Planning Commission Meeting

Major Site Plan Amendment
Intermountain Health Care Clinic Expansion
Thursday, November 10, 2016
Public Hearing

Report Date:	Thursday, November 3, 2016
Applicant:	Levi Lloyd (VCBO Architecture)
Owner:	Intermountain Healthcare (Contact: Ryan Johnson)
Location:	354 Crossroads Blvd.
Major Street Access:	Crossroads Blvd.
Parcel Number(s) & Size:	58:032:0161, 58:032:0062, 58:032:0061; ~30 acres
Parcel Zoning:	RC
Adjacent Zoning:	RC, A, R-3
Current Use of Parcel:	Existing IHC clinic
Adjacent Uses:	Agricultural, Regional Commercial
Previous Meetings:	4/15/08 PC and 4/22/08 CC for approval of original site plan/rezone/MPA/Conditional Use
Previous Approvals:	Site Plan, MDA, CUP
Type of Action:	Administrative
Land Use Authority:	Planning Commission
Future Routing:	None
Author:	Sarah Carroll / Jeff Attermann

C1.00

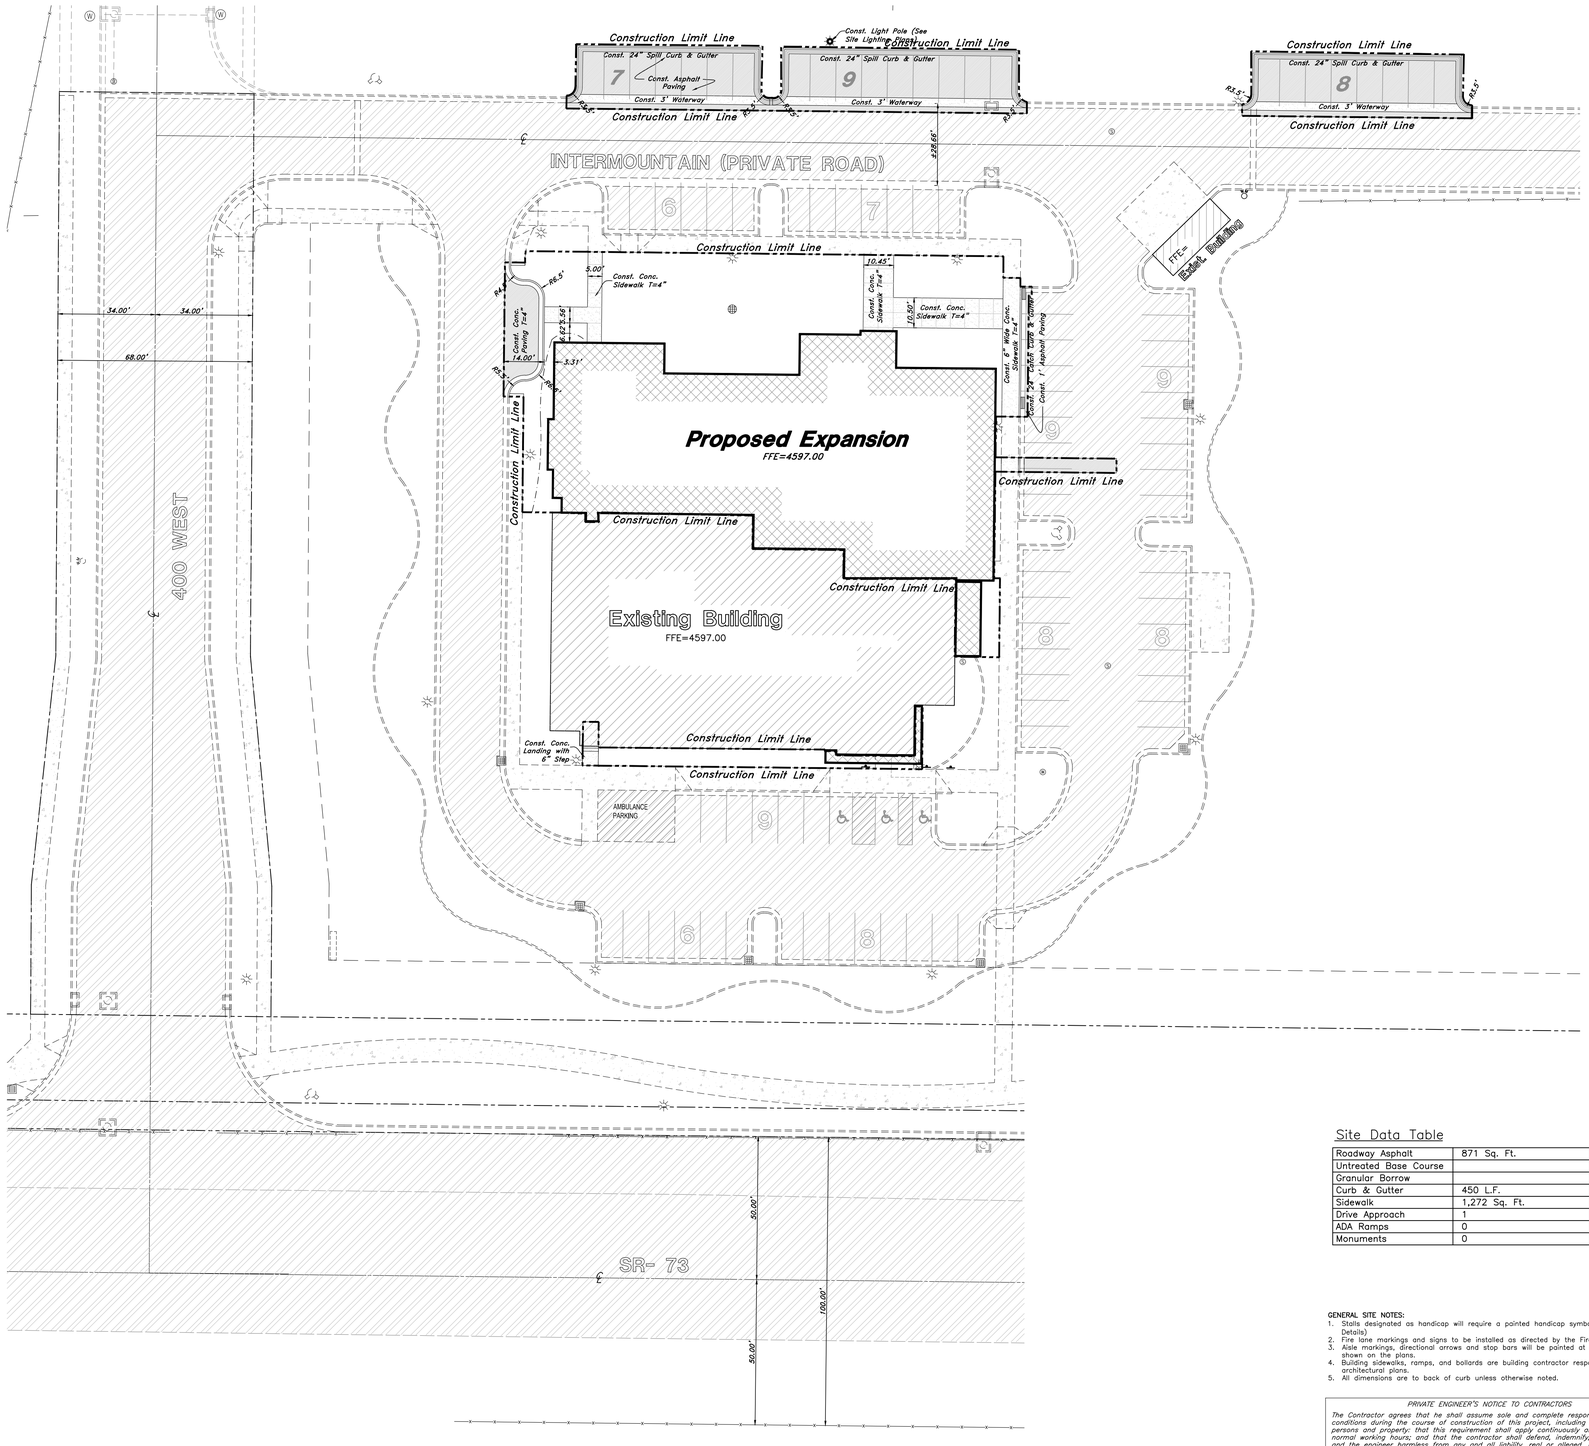
8. Add buffering and screening between the parking stalls on the north and the agricultural uses to comply with Section 19.14. This may be in the form of a wall, fence, or landscaping.
9. All other Code requirements shall be met.
10. Any other conditions or changes as articulated by the Planning Commission: _____.

- UDC: 10/24/16: move stalls from intersection for increased safety/circulation. Verify whether or not design guidelines allow metal on the building (It is allowed per Section 5.B.)
- Neighborhood Meeting: N/A
- PC: Scheduled for 11/10/16
- CC: To be determined

L.L101

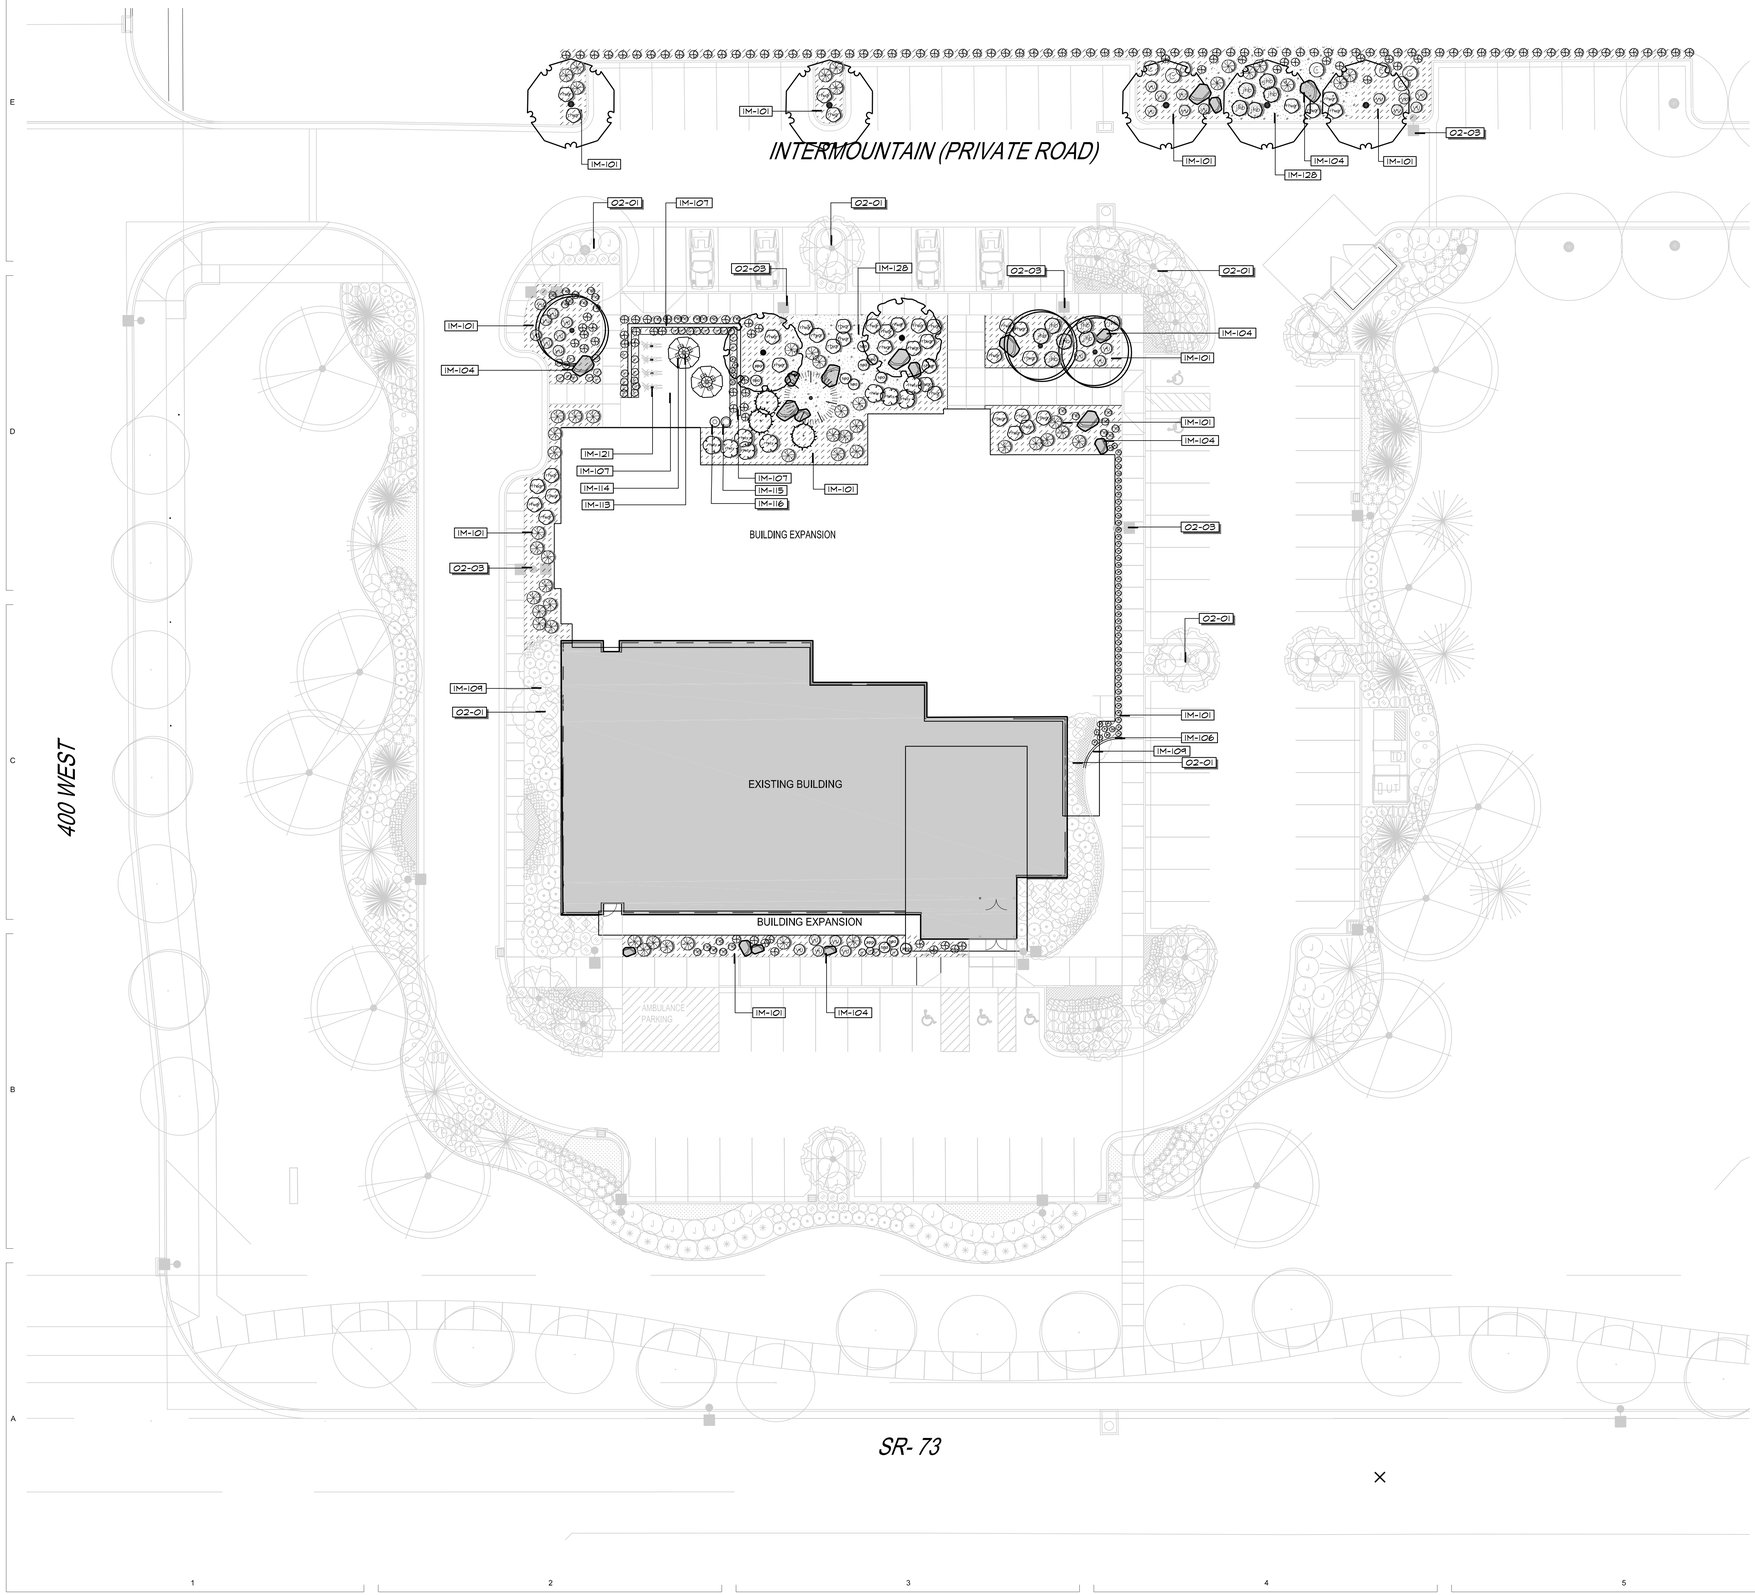
- Tree base clearance: **Can Comply – add detail and/or note to plans.** A 36" diameter surrounding all trees is required to remain clear of rock and turf. This is not specified within the plans.

- Rock: **Can Comply – add note to plans.** A minimum of two separate sizes and two separate colors shall be used and rock shall provide a contrasting color to pavement and other hard surfaces within the property. Two types of rock are shown within the plans but there is no indication of color or size of rock mulch.

- Shrub beds: **Can Comply – add note to plans**
            - High quality weed barriers are required in all planting beds. The use of these barriers is not specified within plans.

- Amount of Required Landscaping: **Can Comply – add City's requirement to table to verify compliance and add amount of turf.**
        - The number of each type of existing plant to remain must be included in plans in addition to the proposed new plants.

1. All conditions of the City Engineer shall be met, including but not limited to those in the attached Engineering staff report.
2. Add notes and/or details to the plans regarding tree base clearance. A 3' diameter at the tree base is to remain clear of rock and turf per Section 19.06

3. Add notes regarding rock color to the plans. Two separate colors and sizes are required per Section 19.06
4. Add notes regarding weed barrier to the plans. High quality weed barrier is required per Section 19.06.

5. Add the amount of turf within the project to verify compliance with Section 19.06 which requires 35% turf.
6. Provide information and details on parking lot and building lighting to verify compliance. Lighting shall comply with Section 19.11.
